Blumel Hall

Re-pipe & Remodel

PORTLAND STATE UNIVERSITY

Revisions :	Date :
1 5 / 4 / 12 ADDENDUM #1	4/17/12

A4.2

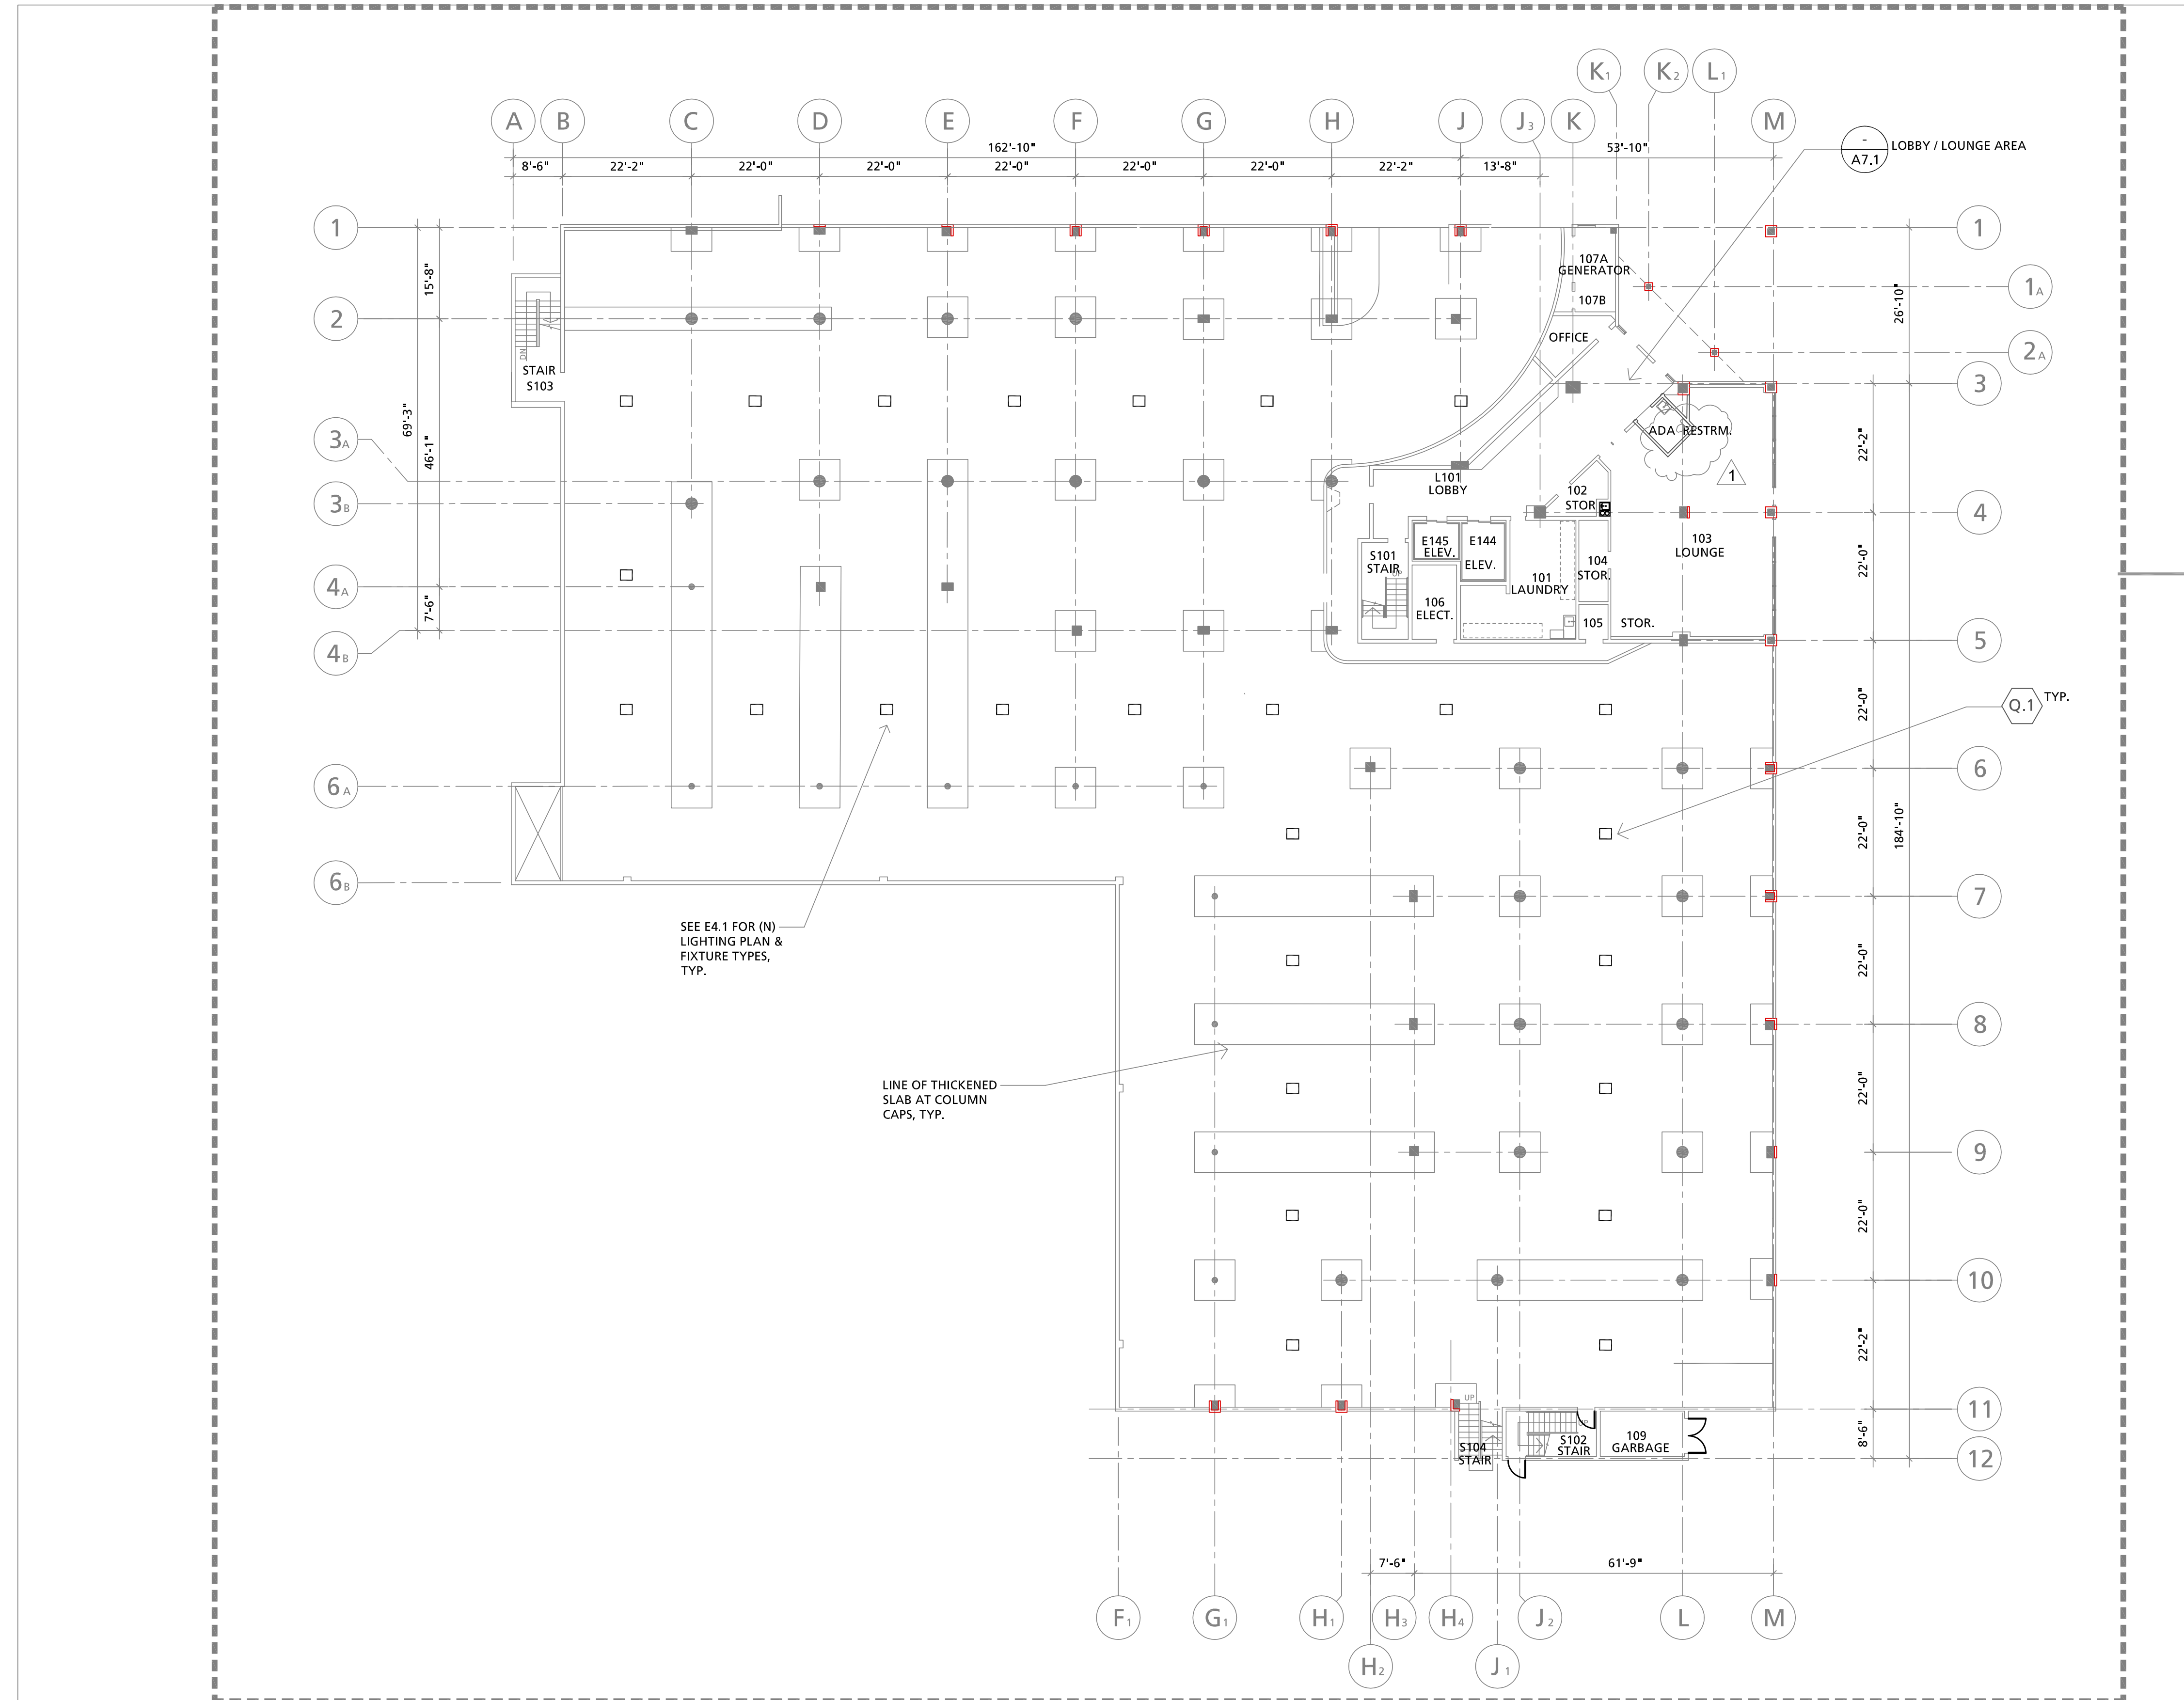
PSU Facilities and Planning
Joseph C. Blumel Hall
Residence Hall
 RE-PIPE REMODEL
 (Block 268)
 1705 SW 11th Ave.
 Portland, Oregon 97201

A6.1

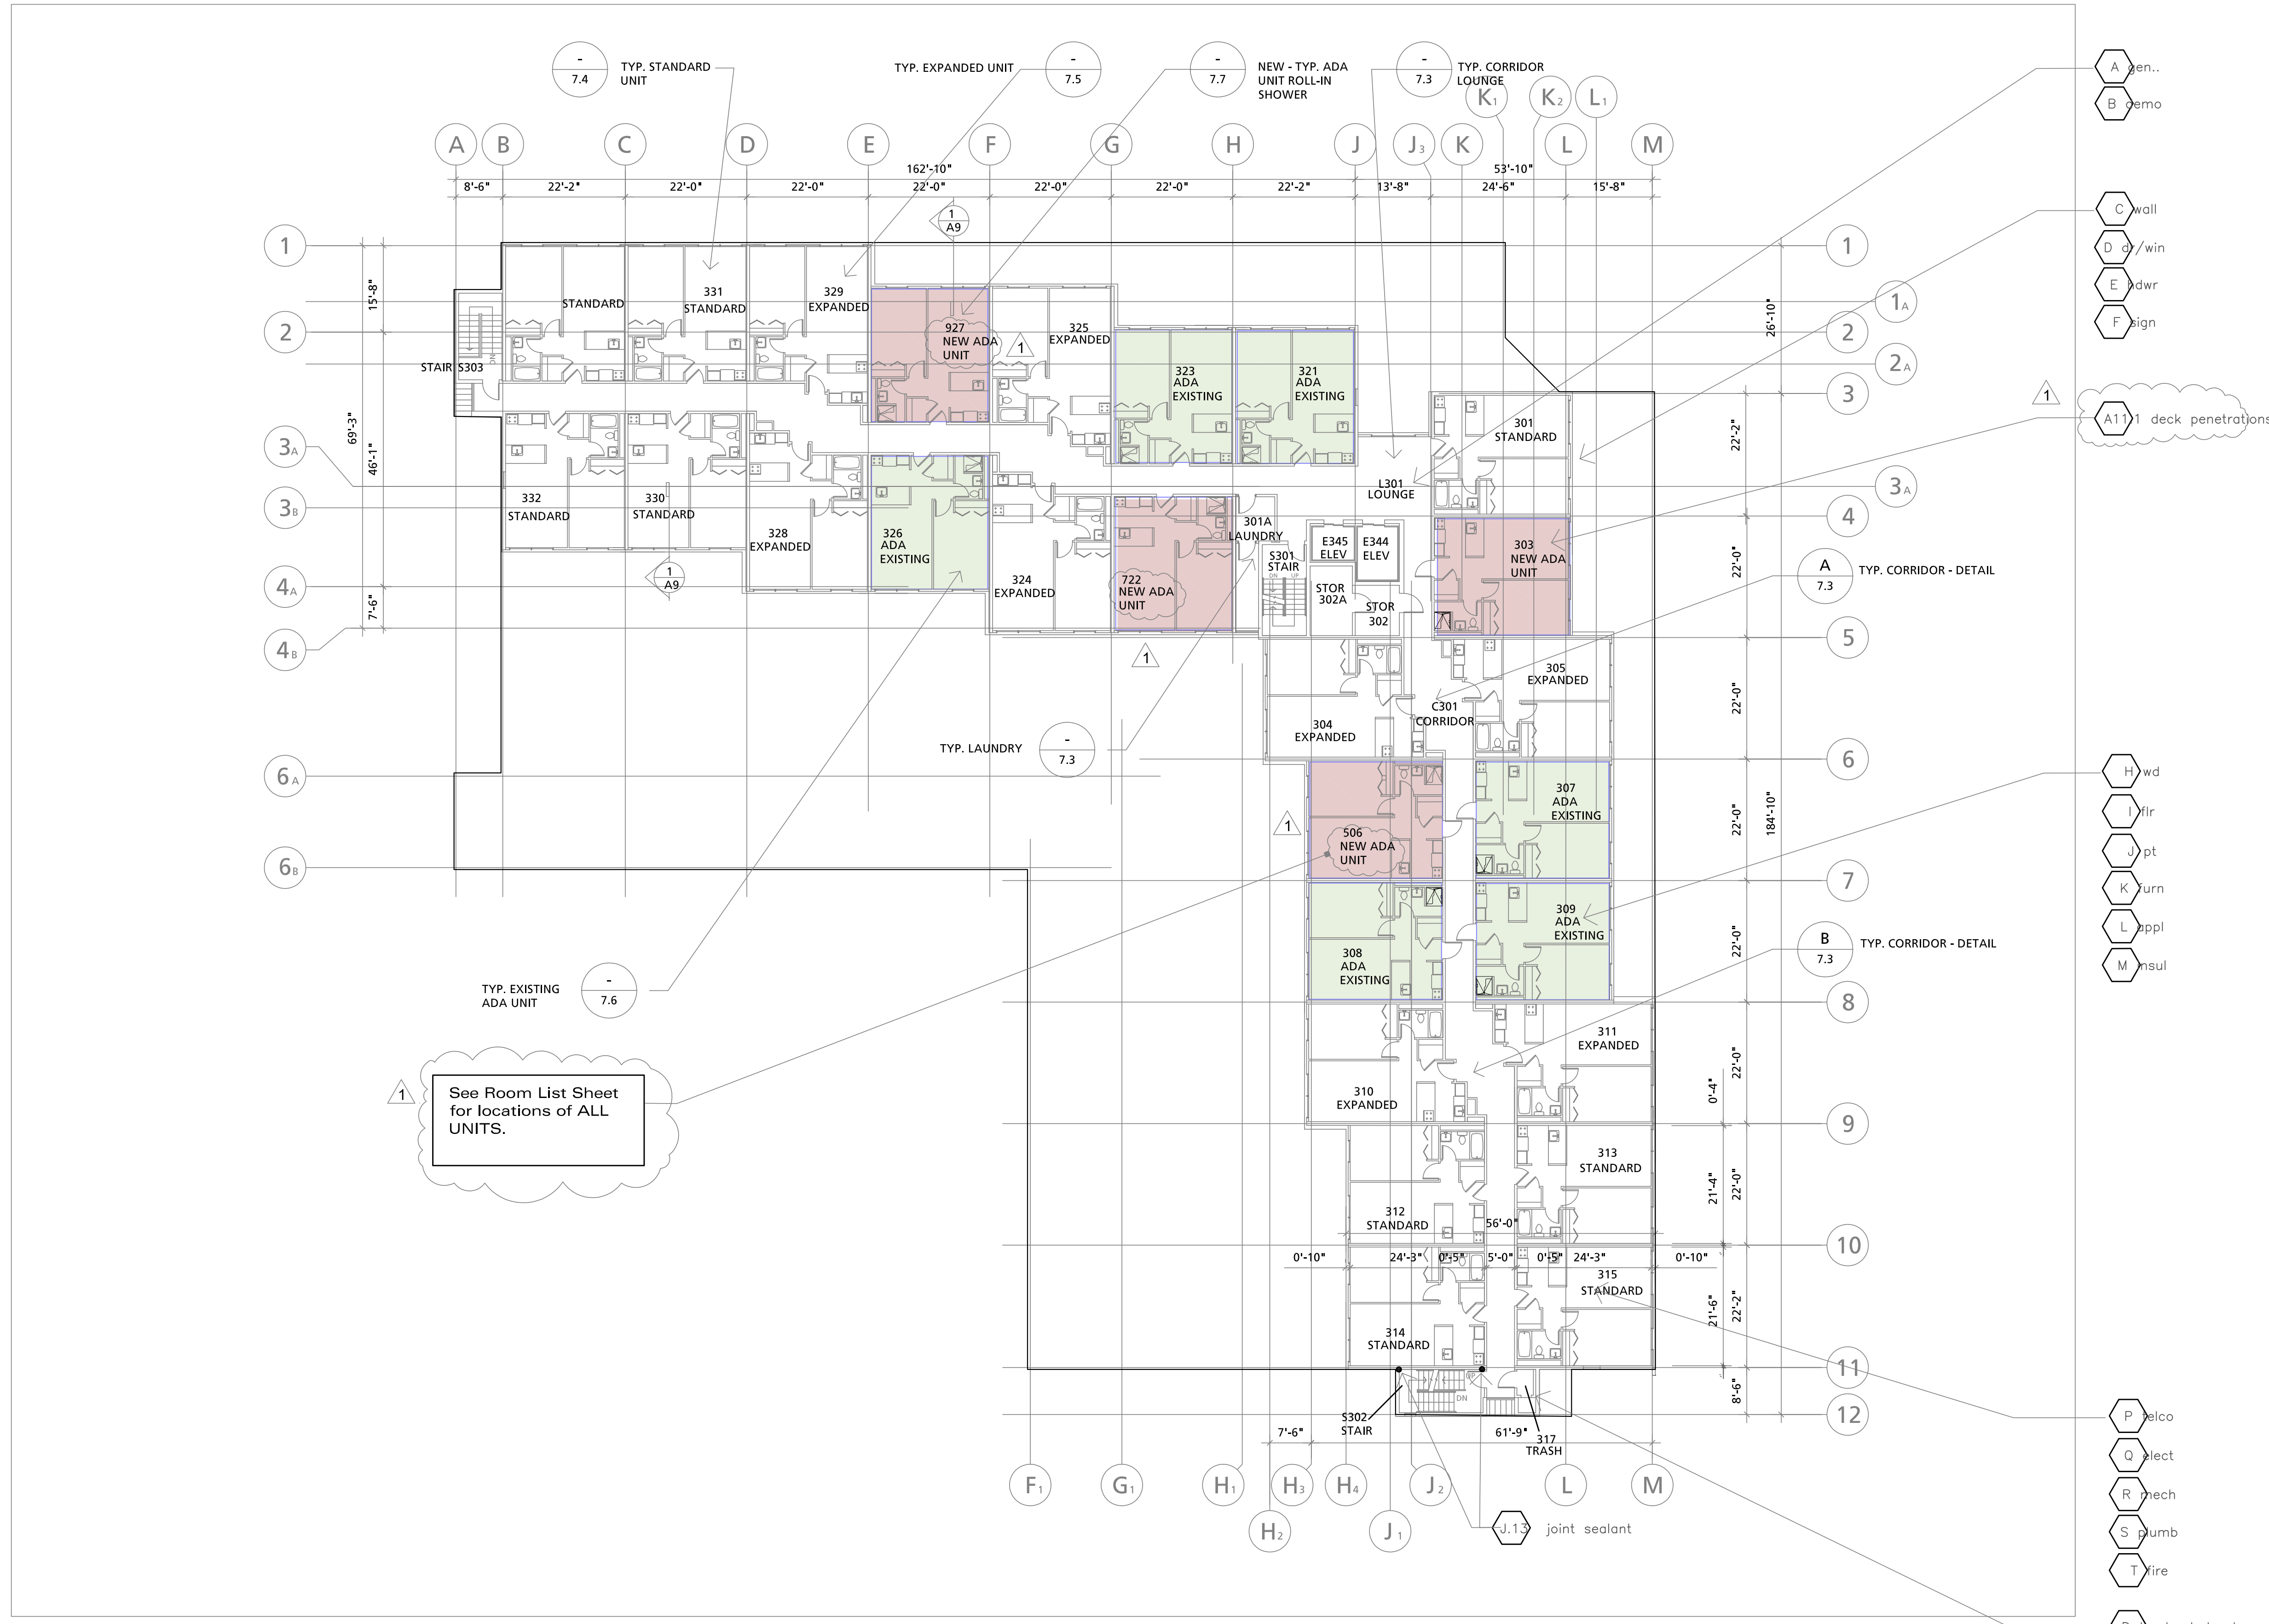
Plan Notes
